**San Diego County Regional Airport Authority (SDCRAA)
Flight Procedure Evaluation
Technical Advisory Committee Meeting #2**

San Diego International Airport

May 31, 2018

DRAFT Deliberative Document – For Discussion Purposes Only

ANAC Noise Recommendation 14 – Existing Flight Tracks

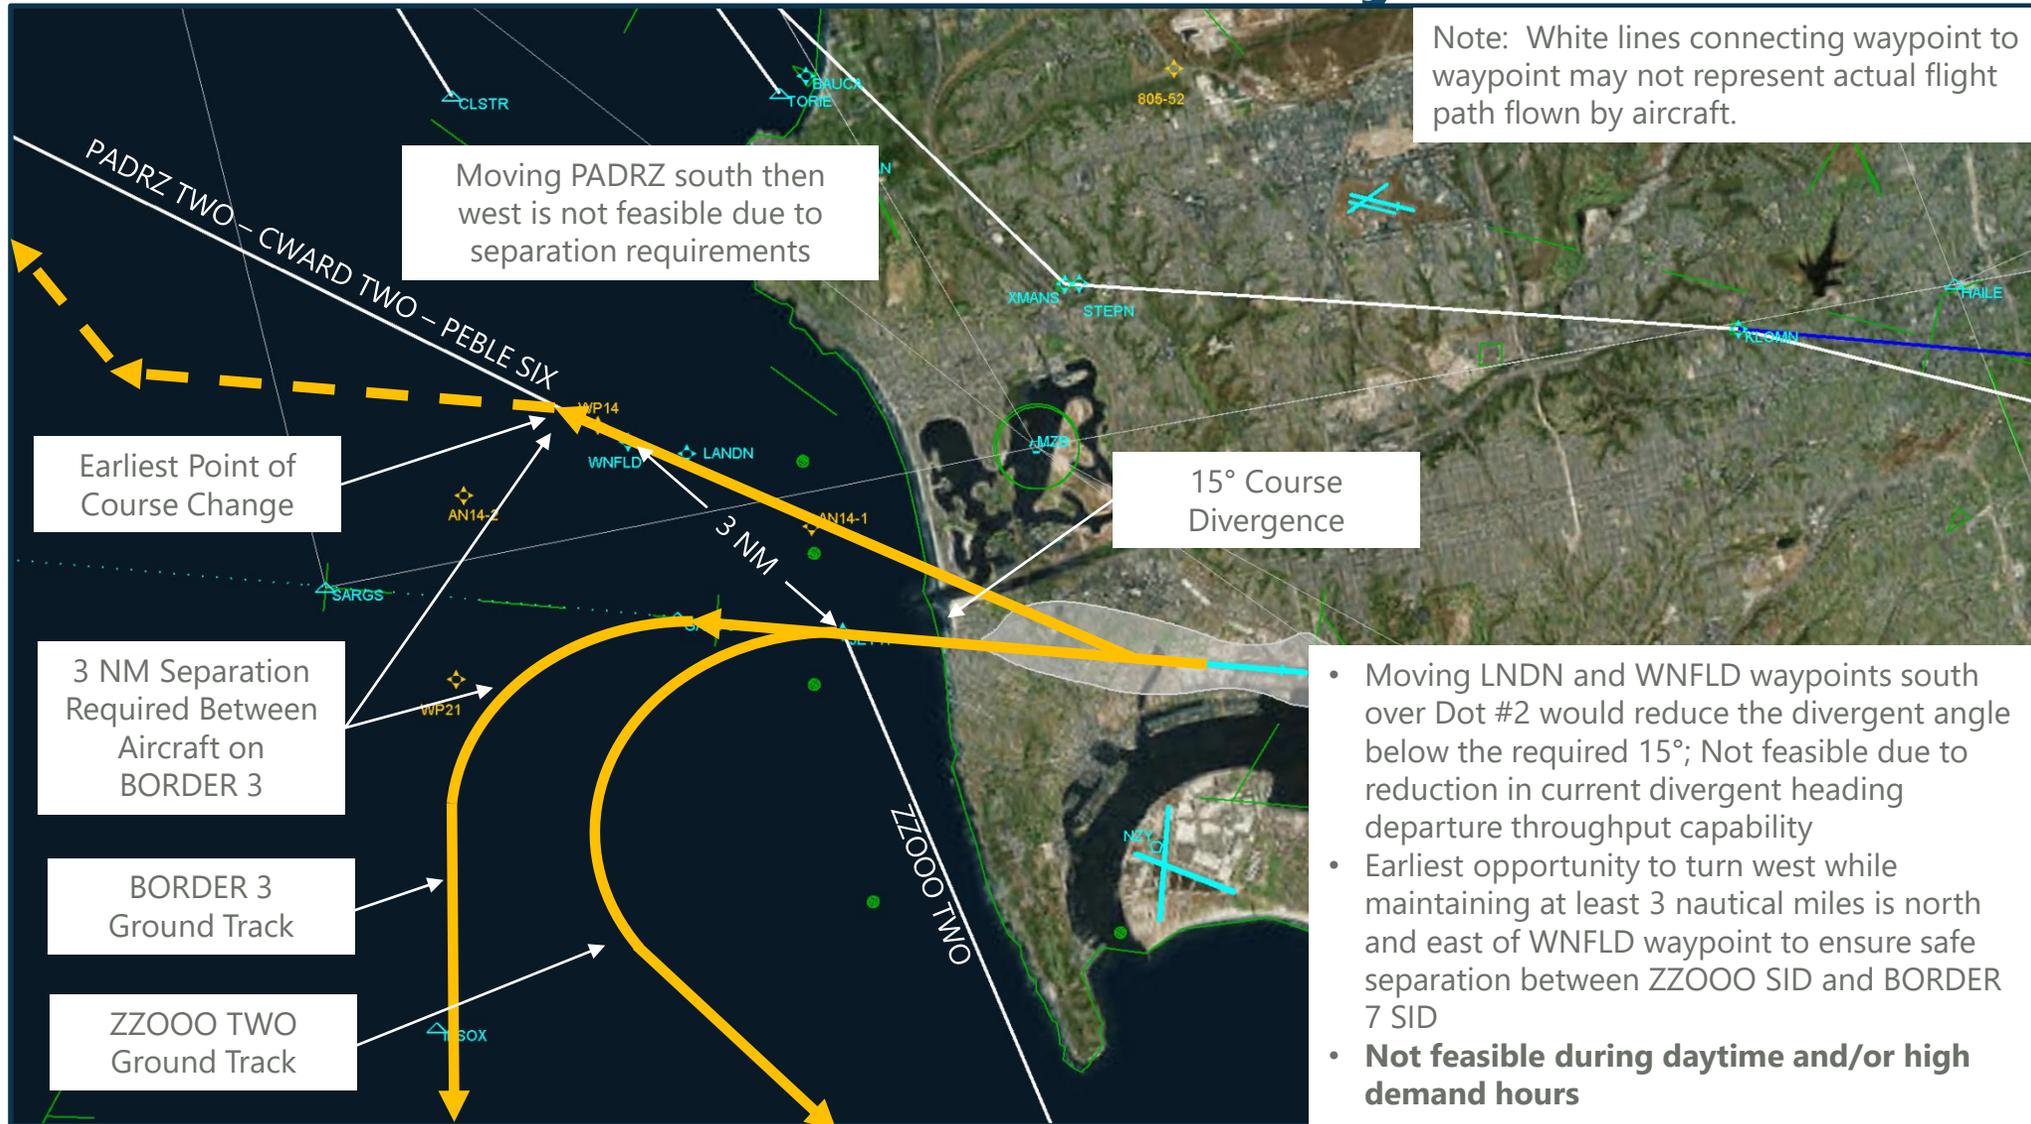
Revise PADRZ SID or create a new procedure to reduce increased noise in La Jolla, Mission Beach and Pacific Beach To be studied as part of the FAR Part 150 Study

1. Move the WNFLD and LANDN waypoints south so as to align with the relocated Noise Dot #1 at 290° (15° separation from JETTI at 275°) and designate as “Flyover” waypoints in their respective SID’s, consistent with JETTI.

2. Establish within the PADRZ SID procedure a horizontal distance from end of runway (1.0 miles) along a fixed heading which must be satisfied along with altitude before a right turn can be initiated to preclude flights that quickly attain the current 520’ altitude and turn right of and prior to Noise Dot #1 before correcting to WYNFLD which results in aircraft flying farther north over Mission Beach.

3. PADRZ ONE SID As currently designed the PADRZ ONE departure leaves aircraft very close to and almost paralleling the coast along La Jolla, increasing noise impacts significantly. We recommend moving the WNFLD and KERNL waypoints 1.5NM south of their current positions. This will ensure aircraft proceed more directly off the coast without paralleling the shore and adds less than a mile of track distance to PADRZ.

4. Create a new procedure: BROCK-1 (alternative 1) Request FAA to revise PADRZ SID and establish new waypoint BROCK1. Adds min increased flight time and takes aircraft further offshore before turning to northern destinations. This will help all coastal neighborhoods with noise issues.

5. Create a new procedure: BROCK-2 (alternative 2 - preferred) Relocate Waypoints WNFLD and LANDN 0.75 miles directly south or adopt BROCK recommendation. Maintain 274 Departure until Altitude 520 or greater. Maintain 274 departure heading until 520 foot altitude or greater and the aircraft have reached (new) flyover waypoint 0.25 to 0.5 miles from the end of the runway before turning towards WNFLD, LANDN or new BROCK Waypoint.

6. Do not move the PADRZ SID further south to avoid negative noise impacts on the south side communities of the Point Loma Peninsula.

1. *Move LNDN and WNFLD waypoint south in line with Dot #2:*
 - The magnetic heading from the departure end of Runway 27 is 287°, which is 12° from 275° heading. Moving LNDN and WNFLD waypoints south over Dot #2 would reduce the divergent angle below the required 15°.

- Not feasible due to reduction in current divergent heading departure throughput capability
2. *Establish within the PADRZ SID procedure a horizontal distance from end of runway (1.0 miles) along a fixed heading which must be satisfied along with altitude before a right turn:* Change to initial heading design will be evaluated in FAR Part 150 Study

3. *Move WNFLD and KERNL waypoints 1.5 miles south of current location:*
 - If aircraft turn more westerly prior to reaching WNFLD, the divergence angle is no longer 15° ; therefore, the procedure must ensure aircraft heading south and north are laterally separated by 3 nautical miles (note: FAA ATC applies an additional buffer between 0.5 to 1 nautical mile to the 3 nautical mile requirement)

- The earliest opportunity to turn west is north and east of WNFLD waypoint to ensure separation between ZZOOO SID and BORDER 7 SID
4. *Create BROCK-1 procedure:* Is not feasible during daytime hours for same reasons as #3 above, but a procedure similar to the BROCK recommendations for nighttime operations when all traffic is on a 290° heading (existing VA to DF coding) is feasible (see ANAC 14 Alternatives 1, 2 and 3)

5. *Create BROCK-2 procedure:* See #4 above

ANAC Noise Recommendation 15 – Existing Flight Tracks

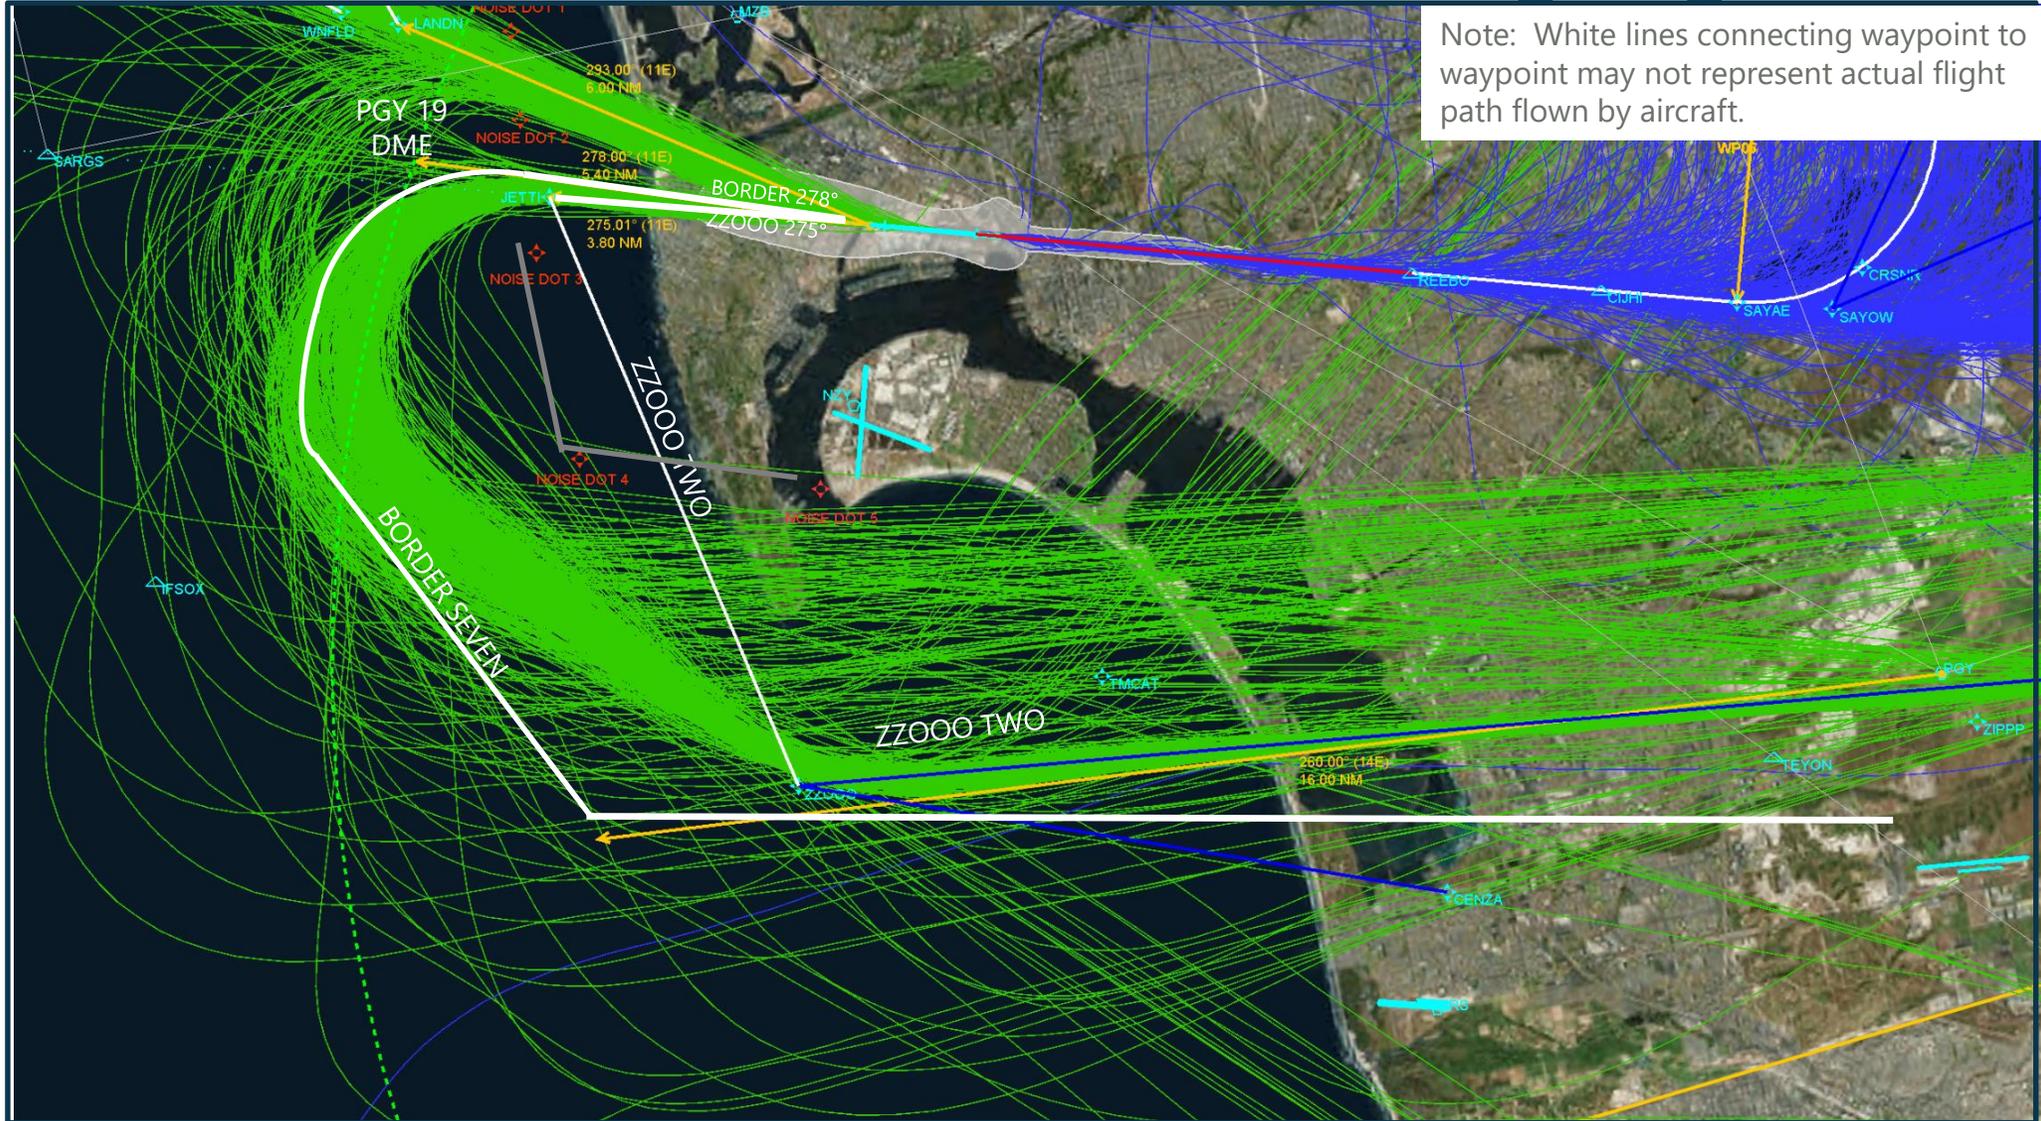
Revise ZZ000 to significantly reduce or eliminate flights over the Point Loma Peninsula, including Cabrillo National Park and reduce or eliminate eastbound turns over La Jolla. To be studied as part of the FAR Part 150 Study

1. East bound flights should reach a minimum of 8K feet before crossing over ZZ000 to minimize thrusters and reduce duration of noise impacts over Point Loma.

2. FAA\TRACON to discourage the practice of redirecting flights off of their filed ZZ000 flight plan departure, to turn north then east over La Jolla. FAA to increase minimum SID flyover\flyby altitudes to encourage increased climb rates.

3. FAA\TRACON to direct that ALL SAN departure separation be limited to between JETTI (275°) and the historical Red Noise Dot #1 (290° vectors from the end of runway 27) for LNSAY, BORDER, PEBLE and ZZ000, etc. (plus all new Metroplex SID's); Prohibit 250° to 275° departure vector range, except for specific safety events ("Runway 27 STAR Missed Approach Wave Off").

4. Follow ZZ000 procedure, comply with the JETTI flyover waypoint and consider the establishment of a minimum vectoring altitude for Eastbound turns.
5. The ZZ000 ONE departure as currently designed puts departing aircraft too close to the Point Loma peninsula and the southern end of coastal La Jolla, subjecting residents to increased and at times incessant noise from departing aircraft. Aircraft need to be further offshore before beginning the turn south to the ZZ000 waypoint. We recommend replacing the JETTI waypoint with a waypoint along the same track from the departure end of runway 27 that is 2 NM further west, located at approximately 32.75360N -117.25755W.

1. *East bound flights should reach a minimum of 8K feet before crossing over ZZOOO:* A requirement of 8,000 MSL at ZZOOO waypoint is not feasible based on existing design of procedure, but may be possible if existing procedure design is modified (see ANAC 15 Alternative 1).

2. *Redirecting flights off of their filed ZZOOO flight plan departure, to turn north then east over La Jolla:* If an RNAV SID is implemented for eastbound departures on a directed 290° heading and thence directed towards ZZOOO waypoint, it would decrease frequency of traffic vectored north then east over La Jolla (ANAC 15 Alternatives 2 and 3 addresses this issue).

3. *Direct that ALL SAN departure separation be limited to between JETTI (275°) and the historical Red Noise Dot #1 (290° vectors from the end of runway 27):* Initial or directed heading at departure to be addressed in FAR Part 150 Study.

4. *Comply with the JETTI flyover waypoint and consider the establishment of a minimum vectoring altitude for Eastbound turns:* ZZOOO SID complies with recommendation for flight paths within 275° heading. ZZOOO SID is an RNAV procedure and has no minimum vectoring altitudes (MVA). MVA is driven by obstacle clearance. If the intent is to raise the altitude on specific segments, MVA is not a feasible method.

5. *Aircraft need to be further offshore before beginning the turn south to the ZZOOO waypoint:* Increasing distance from Point Loma shoreline as aircraft turn back to the east would require a modification to ZZOOO SID design (see ANAC 15 Alternative 1). Moving the JETTI waypoint further west is intended to raise altitude over ZZOOO and increase distance from the Point Loma shoreline (see ANAC 15 Alternative 1).

ANAC Noise Recommendation 16 - Graphic

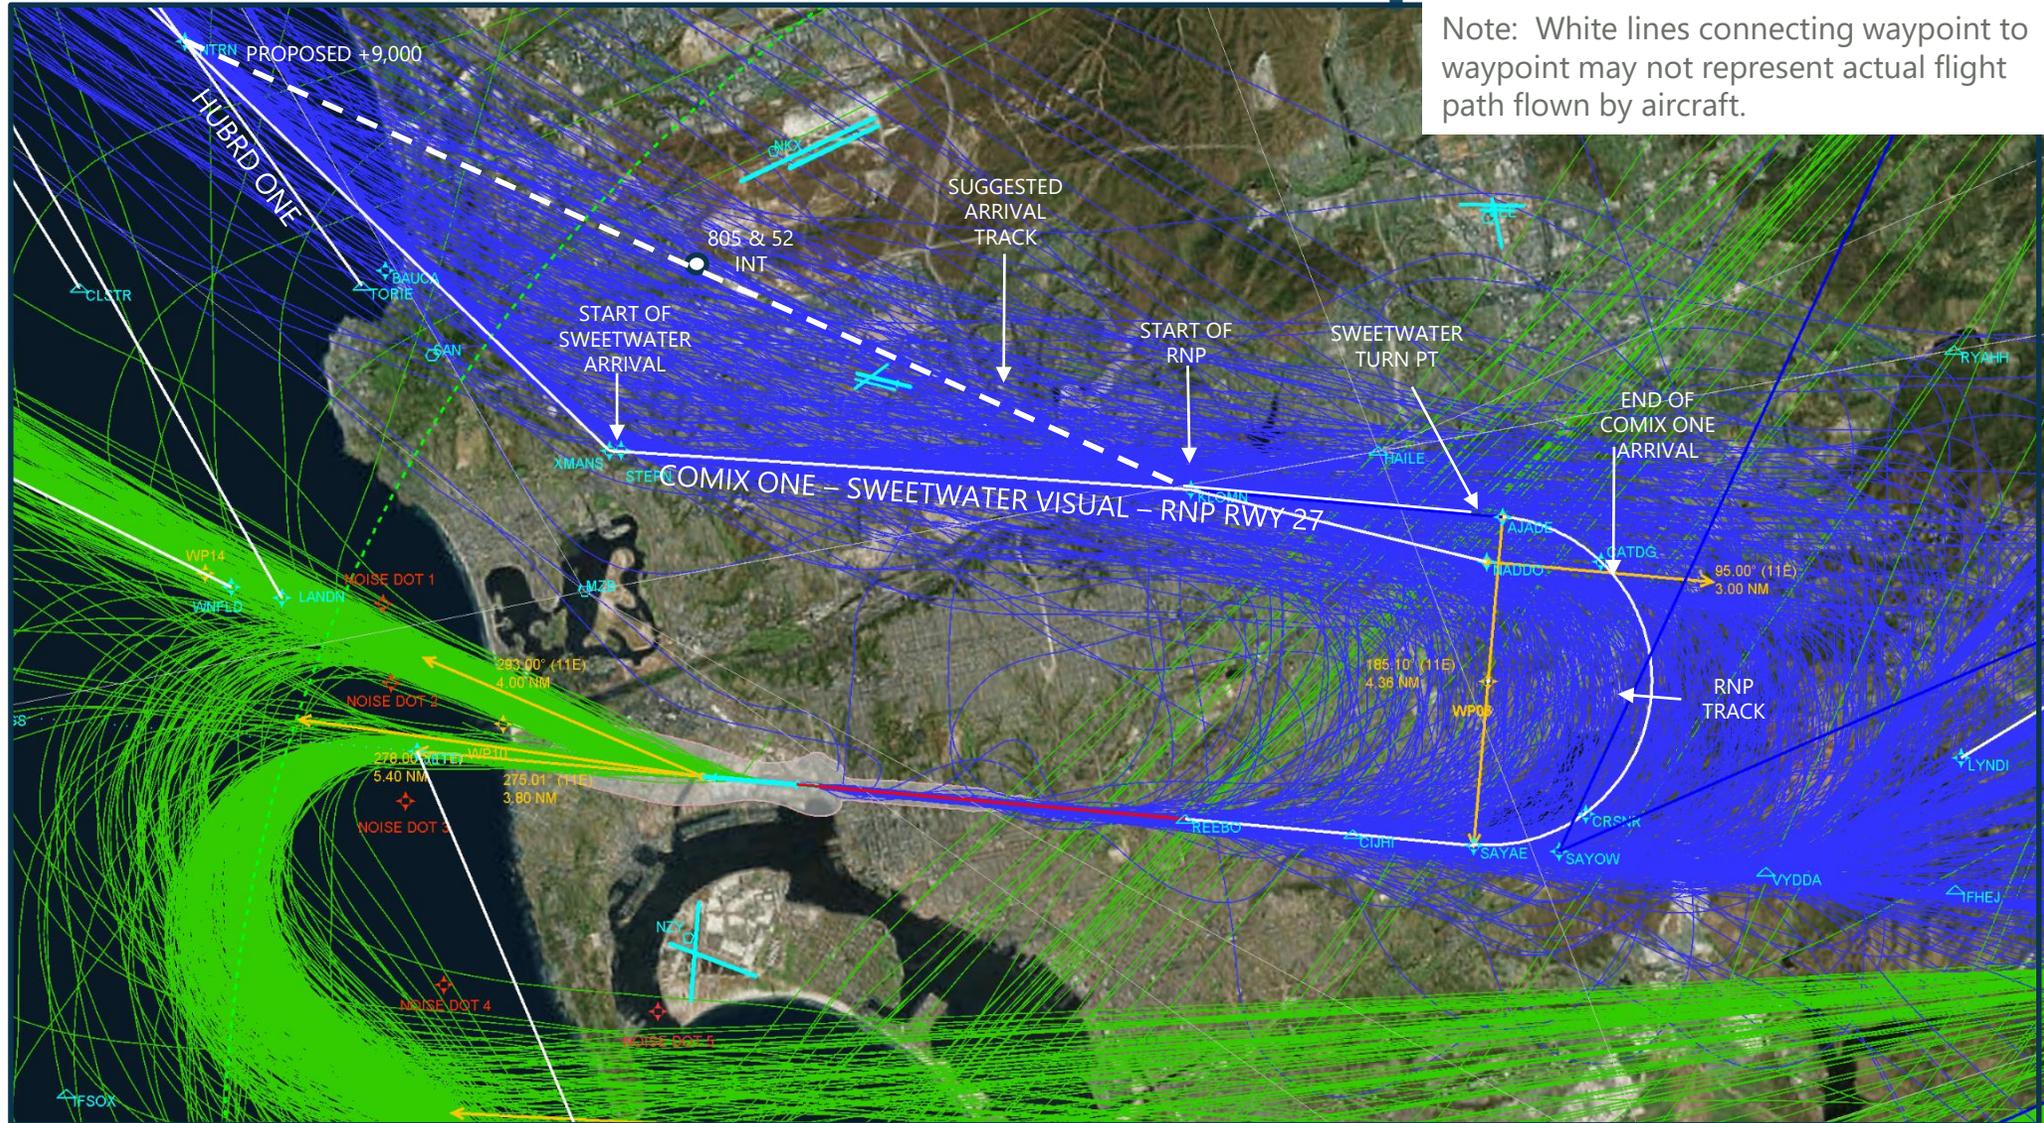
Reassess and revise the entire arrival corridor in a manner that more appropriately “shares the noise” instead of concentrating arrivals from the North in a very narrow corridor.

1. Revise COMIX STAR procedure in order to shift flights that Metroplex has moved and concentrated farther South (the downwind leg) over less populated areas and restore prior altitude.

2. Shift the way point XMANS on the COMIX STAR north to a location that is over the interstate freeway 805 and 52 with the constraint to remain clear of MCAS Miramar's airspace. It would come ashore over Torrey Pines State Park before connecting with KLOMN.

3. Increase Min. Altitude at LNTRN (LCOVE) at or above 10,000. This change would result in aircraft flying over less populated areas, including industrial businesses, thus reducing the noise impact and saving time/fuel. This proposed path is closer to the historical flight tracks pre-NextGen.

4. COMIX ONE STAR: The RNAV-only COMIX ONE arrival is very similar to the existing non-RNAV BAYVU arrival in terms of ground track with a key difference being that the COMIX arrival has an “at or above 8,000 feet” altitude restriction on its last offshore waypoint (LANTRN). The BAYVU arrival has an “at or above 9,000 feet” restriction at its nearly identically-located LCOVE waypoint. This has resulted in aircraft being lower and noisier over La Jolla. We recommend changing the LANTRN waypoint’s altitude restriction to “at or above 9,000 feet”.

1. *Revise COMIX STAR procedure in order to shift flights over less populated areas and restore prior altitude:* Leg between KLOMN waypoint to NADDO waypoint was designed to prevent Class B airspace excursions. This leg cannot be changed until the Class B redesign is complete. Path may be modified post Class B design.

2. *Shift the way point XMANS on the COMIX STAR north to a location that is over the interstate freeway 805 and 52:* Crossing the shoreline over Torey Pines State Park and heading to XMAN waypoint shifted north over I-805 and SR-52 would reduce the flight track 1 nautical mile (NM) (see ANAC Recommendation 16 Alternative 1 and 2)

- Reduction in vectoring and sequencing area may be deemed infeasible by FAA
 - Possible ATC issues with Miramar Marine Corps Air Station
 - Moving noise from one community to another is contrary to FAA policy, and may be deemed infeasible by FAA – aircraft overflight location moved over another community and aircraft are lower in altitude

3. *Increase Min. Altitude at LNTRN (LCOVE) at or above 10,000:* Increasing LNTRN to 10,000 feet is not feasible based on current design
 - Increasing to 10,000 feet would exceed the descent gradient criteria (maximum of 330 feet per nautical mile) from LNTRN to KLOMN waypoint at 6,000 feet MSL along the existing COMIX path.

- Increasing altitude at LNTRN to 10,000 feet along route shifted north would also exceed descent gradient criteria.
4. *Change the LANTRN waypoint’s altitude restriction to “at or above 9,000 feet”:* According to FAA information posted on the FAA Instrument Flight Procedure Gateway Production page for SAN, the COMIX TWO STAR is expected raise the altitude from at or above 8,000 to at or above 9,000 feet at the LNTRN waypoint.
